NEW YORK HARBOR
CHANNEL NAVIGATION IMPROVEMENT 50 FT PROJECT
AMBROSE CHANNEL

CONTRACT2
S–AM–1
W912DS–05–B–0012

Symbol	Description	Date	Rev.
4	Sheet C-35 and C-37 are eliminated and sheet numbers are rearranged accordingly. I thru 35 and Alignment Data sheet All Plan Sheets and Cross sections sheets are revised.	7/19/05	G.A.

COVER SHEET,GENERAL PLAN AND INDEX TO DRAWINGS

PLAN SHEET STA.326+17.7 TO STA.397+55

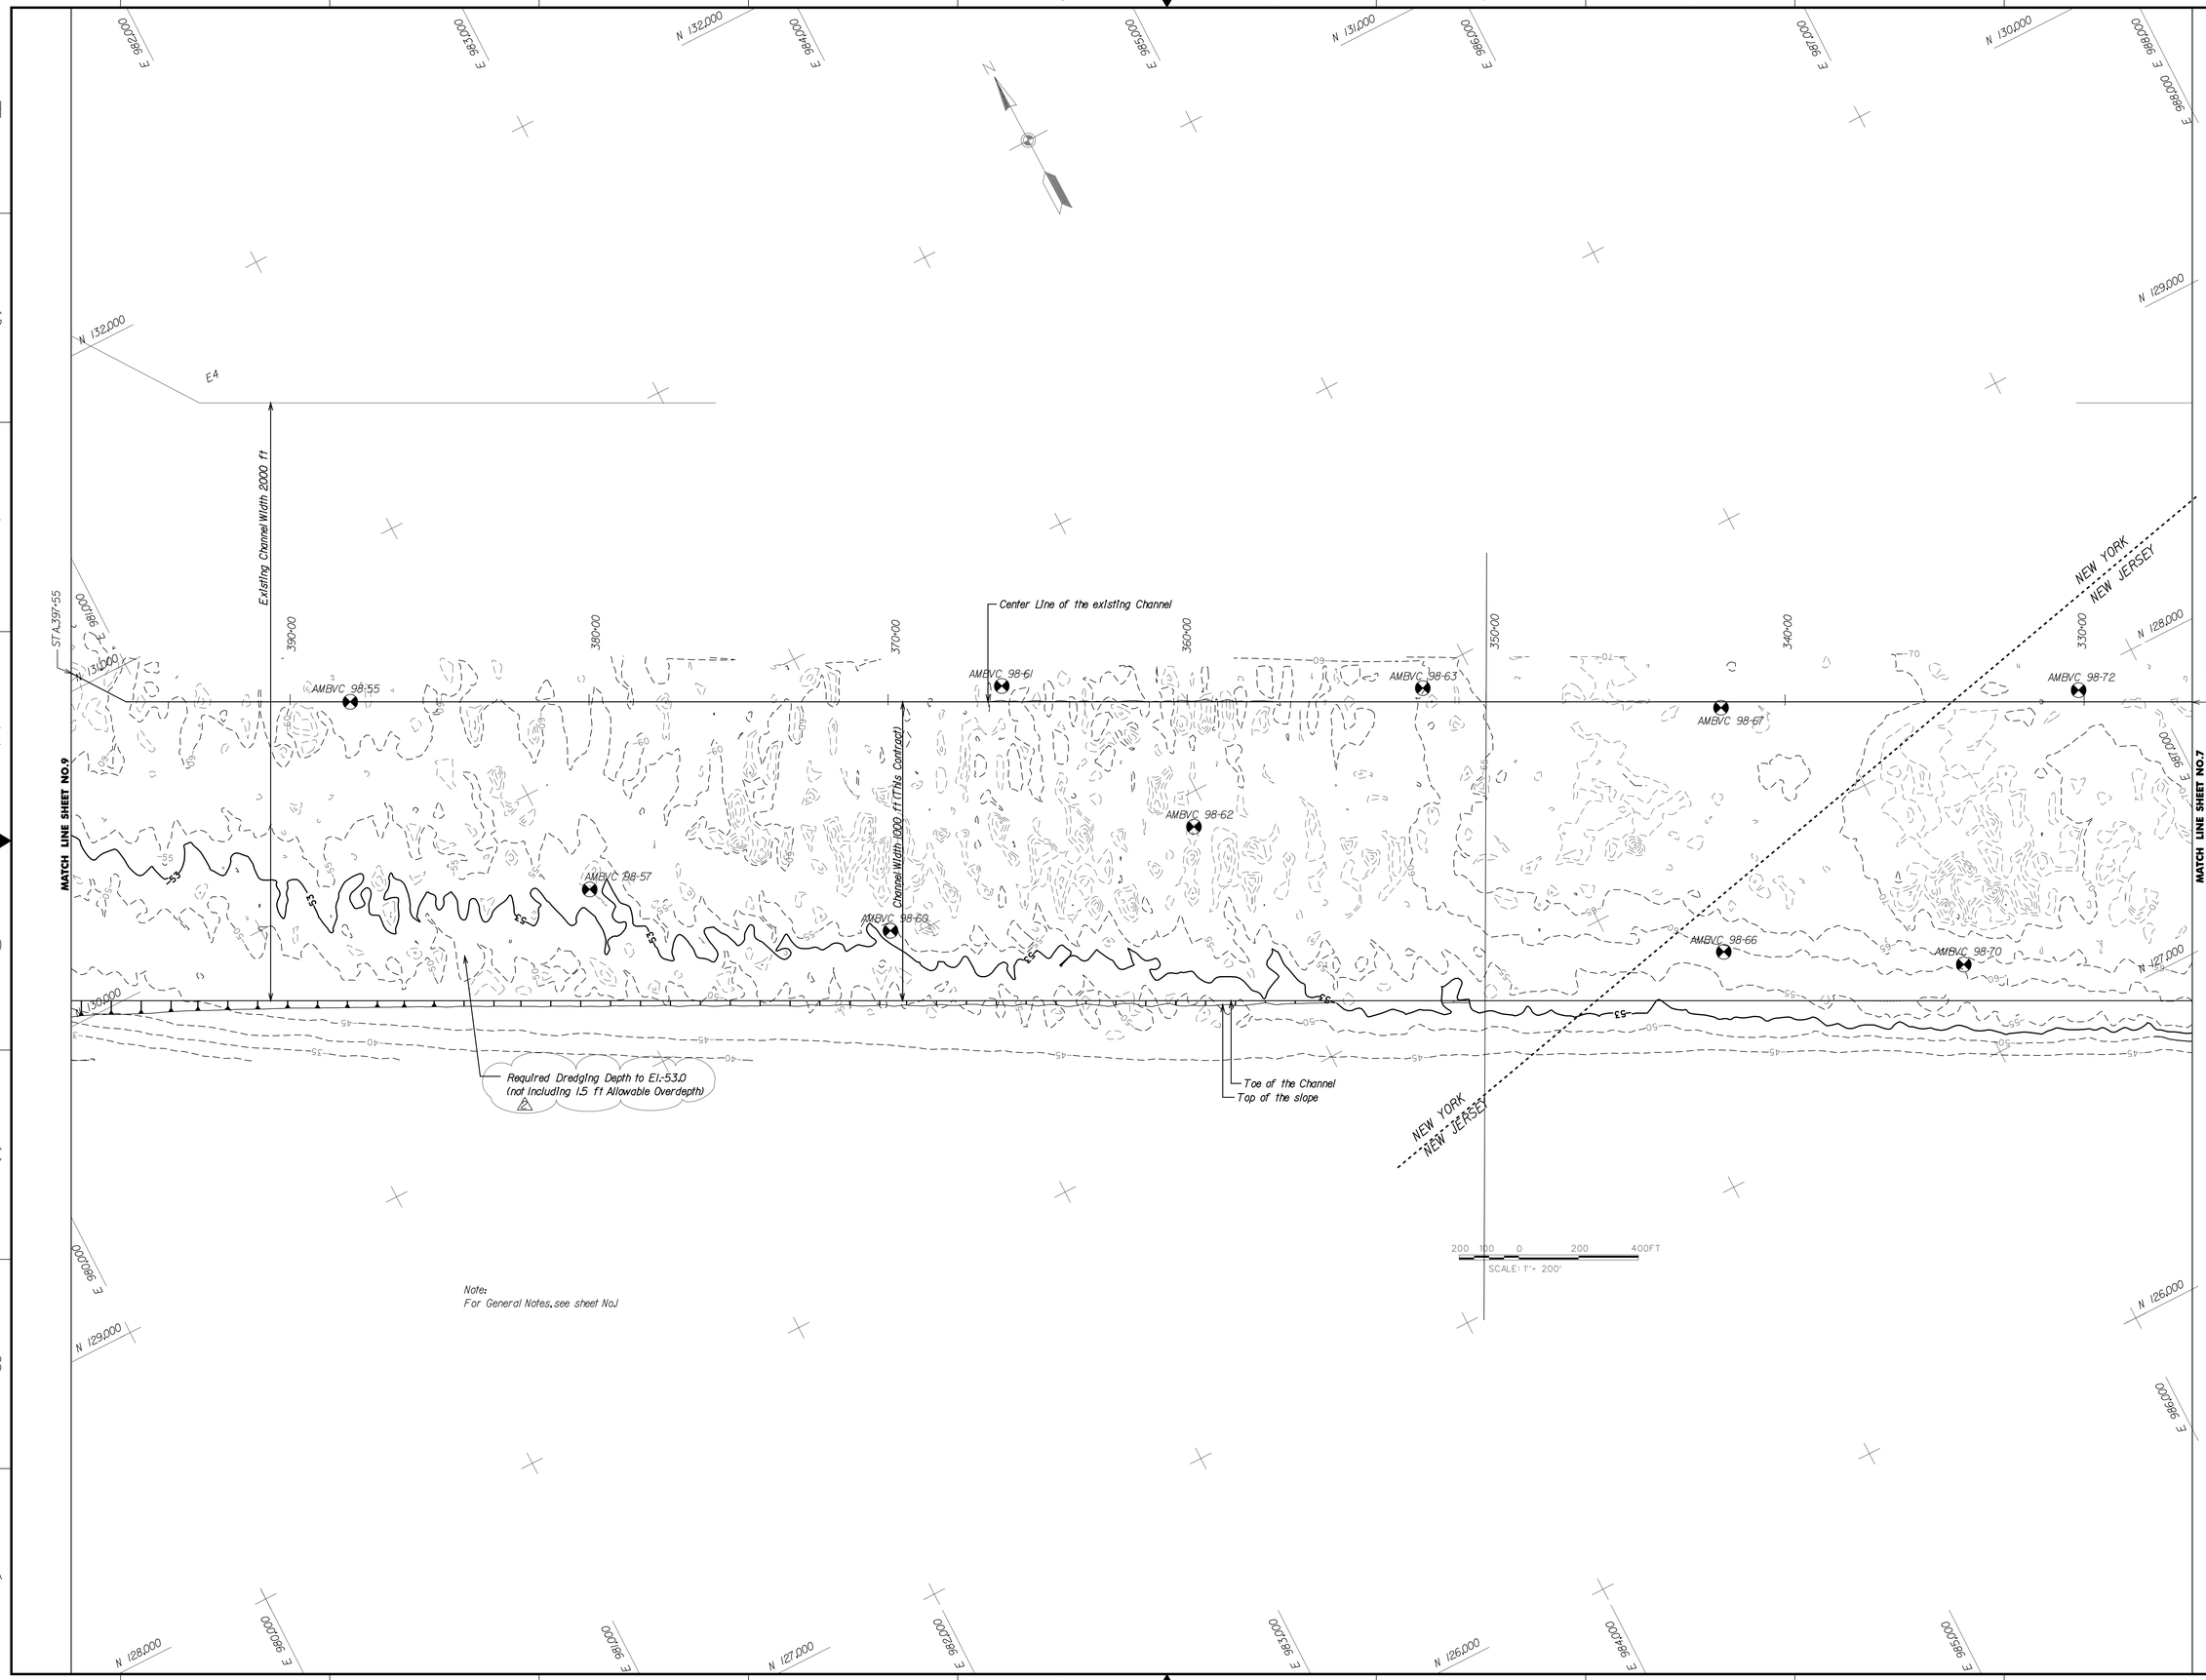
Symbol	Description	Date	Rev.
△	Revised Allowable Overdepth	7/19/05	G.A.

PLAN SHEET STA.461+97 TO STA.533+72

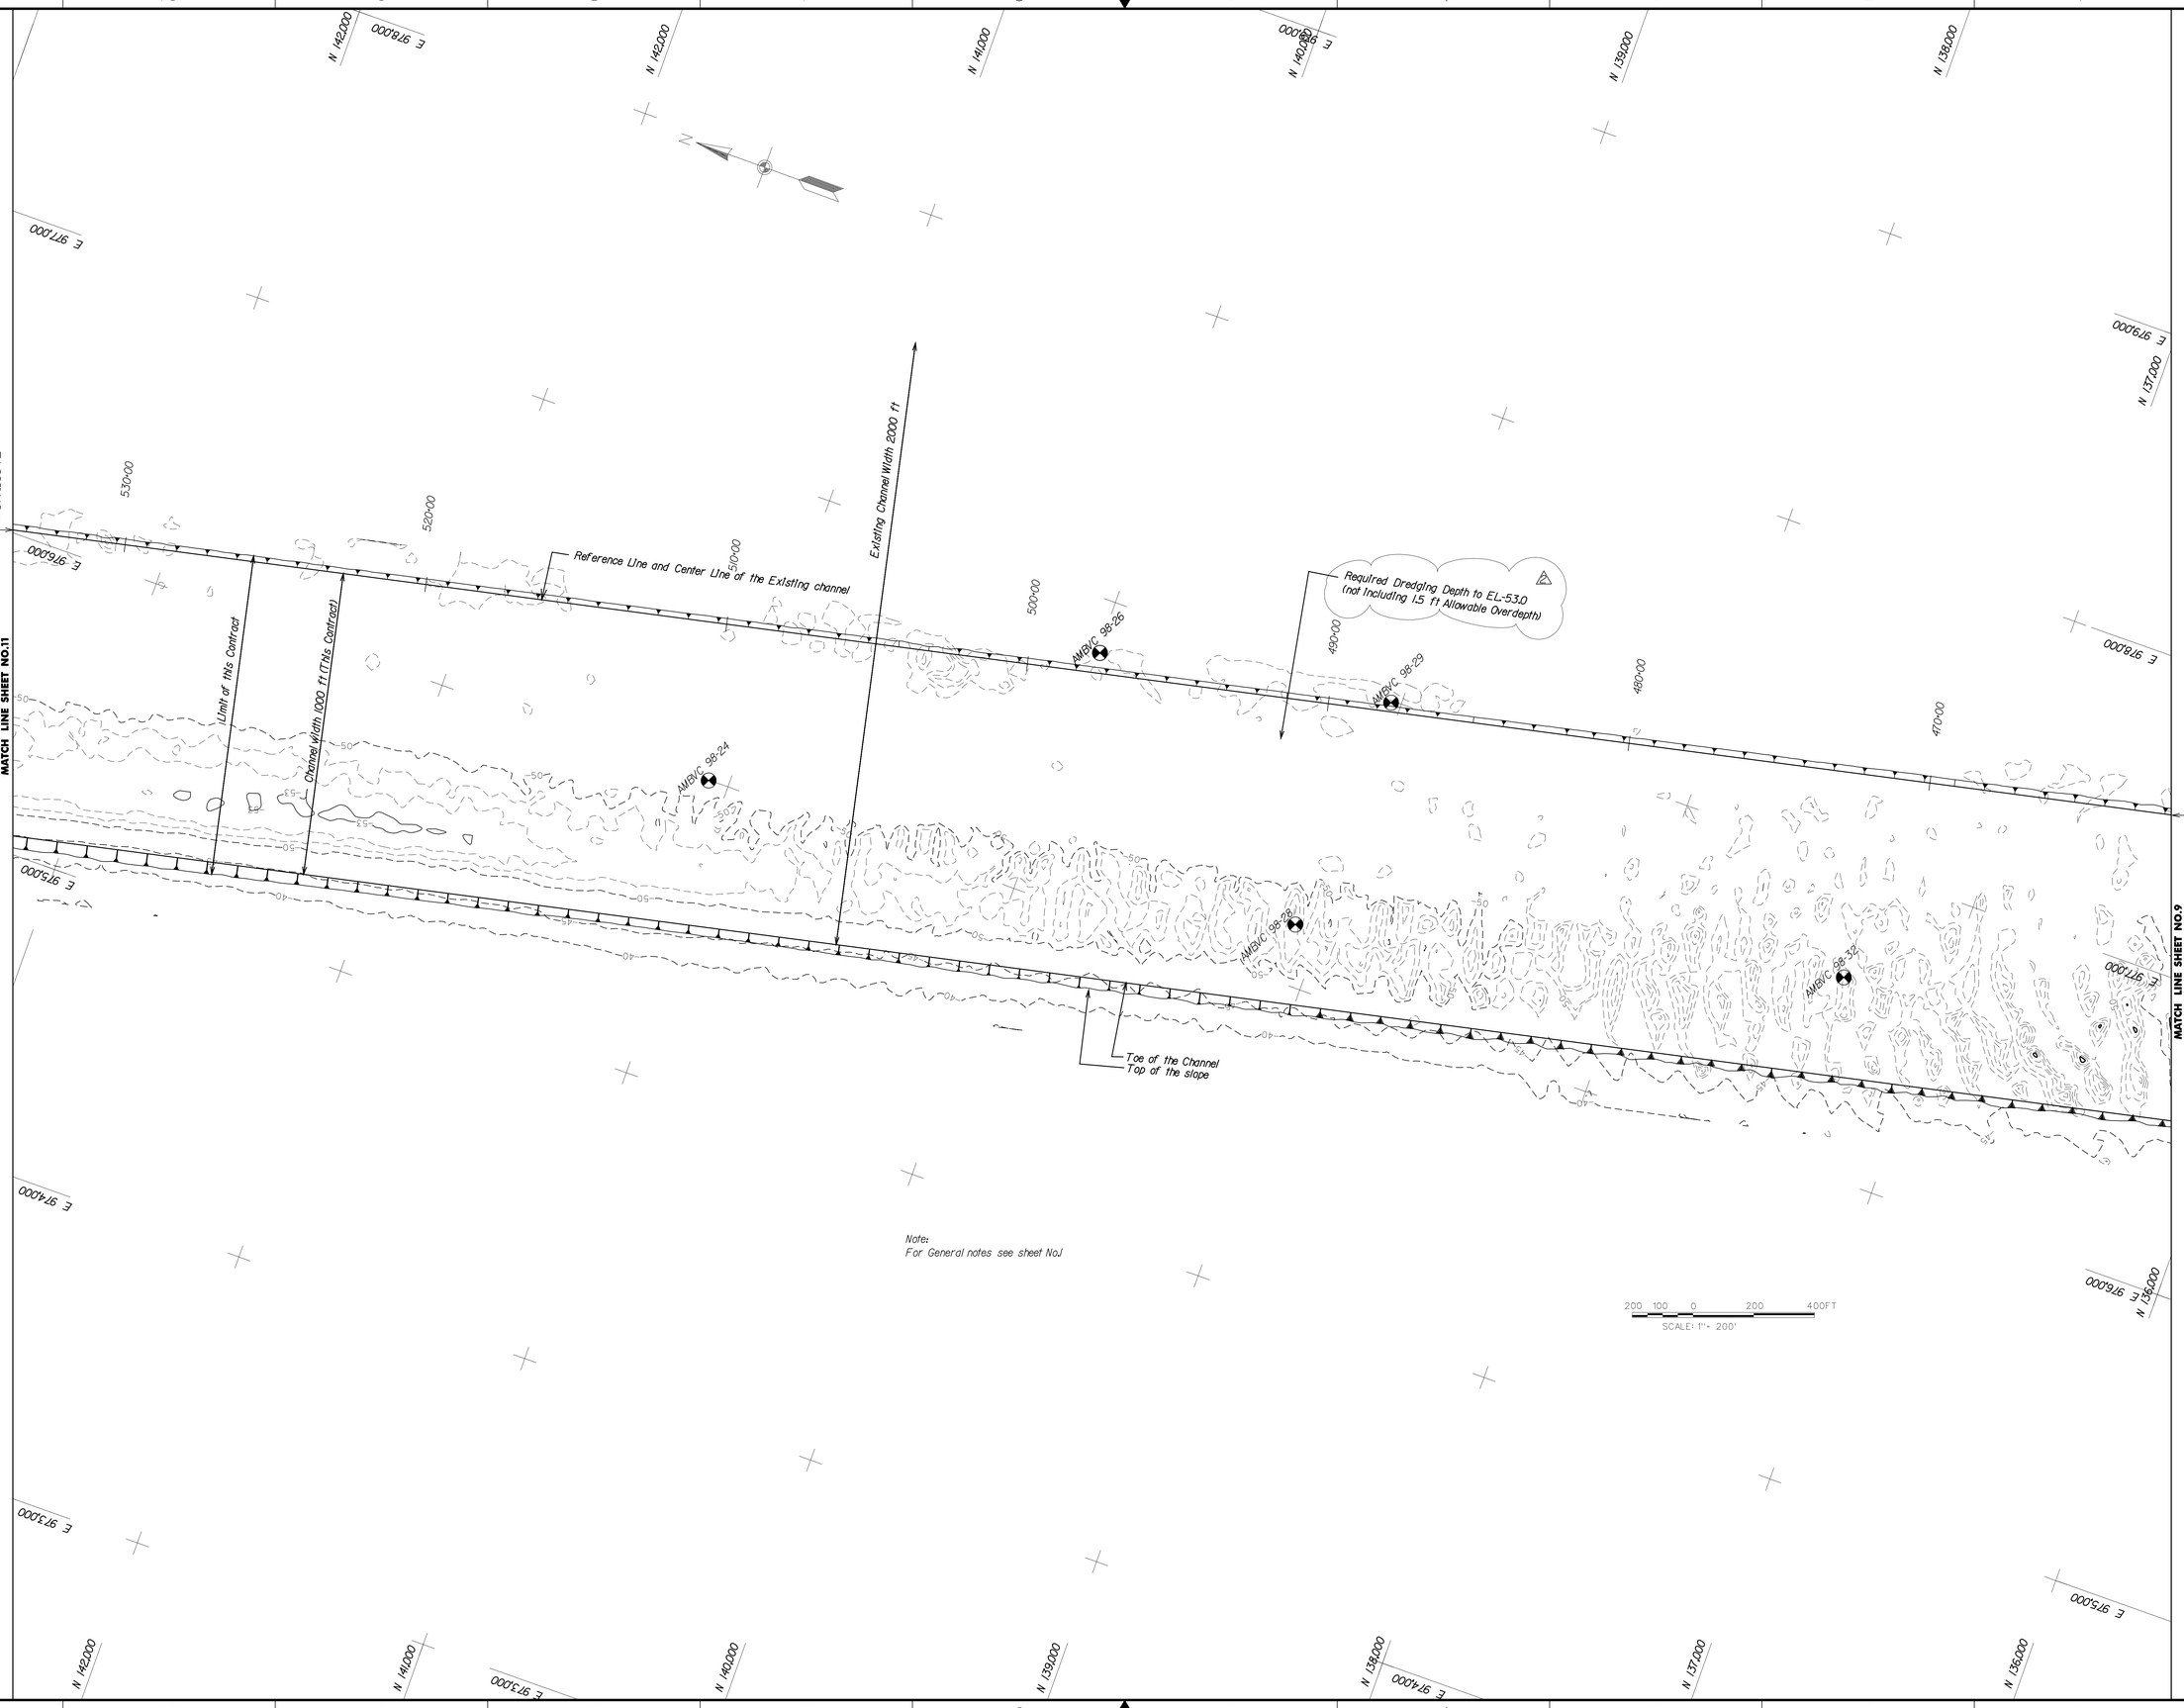
Rev.	Date	Description	Checked
A	7/29/08	Revised Allowable Overdepth	G.A.

NEW YORK HARBOR
CHANNEL NAVIGATION IMPROVEMENT 50 FT PROJECT
AMBROSE CHANNEL
CONTRACT 2
S-AM-1
PLAN SHEET STA533+72 TO STA605+48.7

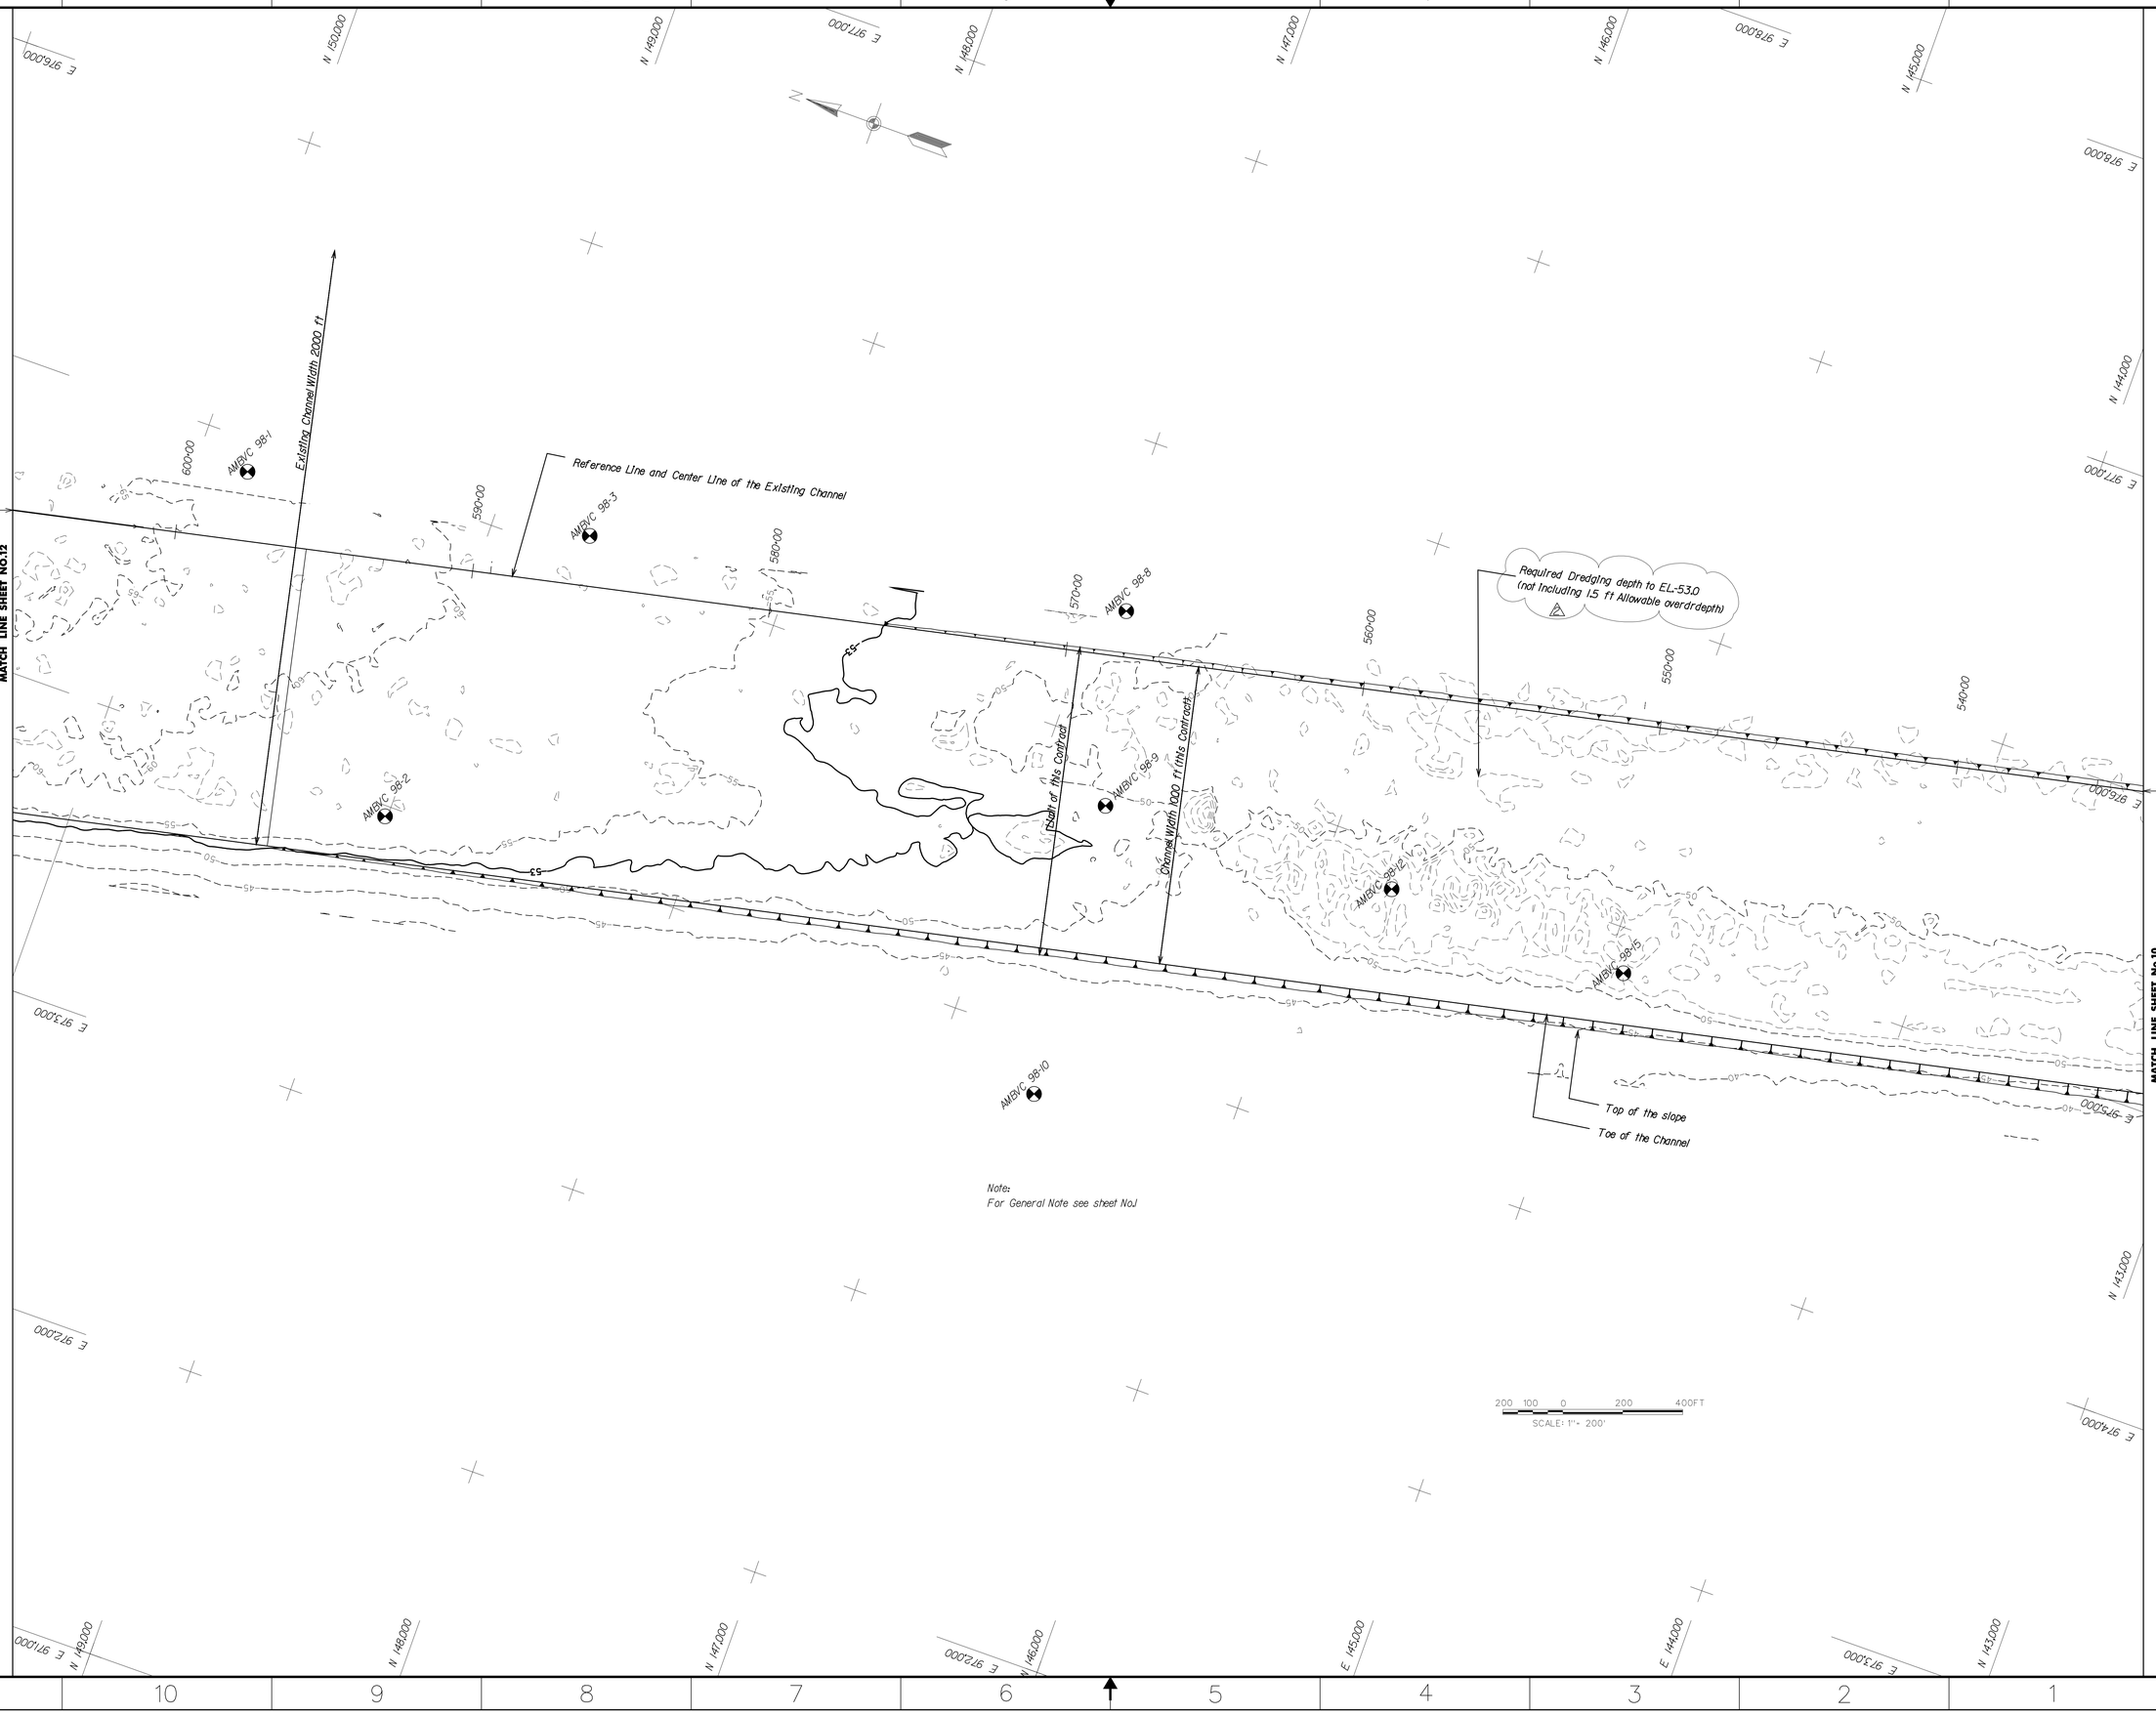
Symbol	Description	Date	By
A	Revised Allowable Overdepth	7/19/05	G.A.
